Date: **September 20, 1999**

Subject: **RESTORING WHITE BALANCE**

Model: **BVM-8044QD, PVM-5041Q, PVM-8040  
 PVM-8041Q, PVM-8043MD, PVM-8044Q  
 SSM-8040**

**Figure 1**

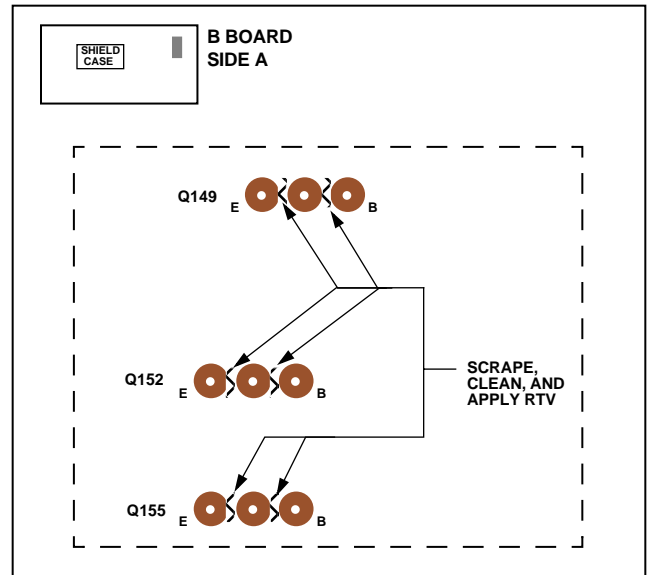
If the insulation for transistors Q149, Q152 and Q155 on the B board is insufficient and current leakage occurs, white balance may not be achieved when the CRT is replaced.

**Side A, Zones A-9, B-9 (See Figure 1.)**

1. *Carefully* scrape with knife areas between collector and emitter and between collector and base of Q149, Q152 and Q155 as shown.

**NOTE:** Be careful not to cut any traces in the vicinity.

2. Clean scraped areas.
3. Apply RTV to scraped areas.
4. Readjust white balance.

**Figure 2**

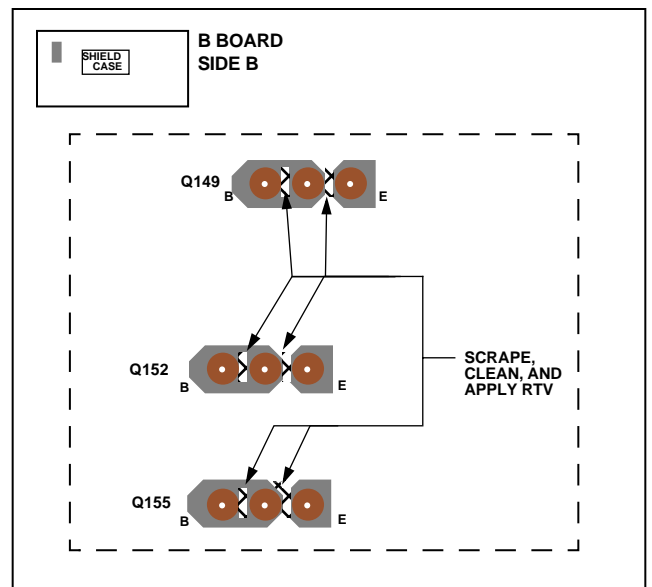
**Side B, Zones A-2, B-1 (See Figure 2.)**
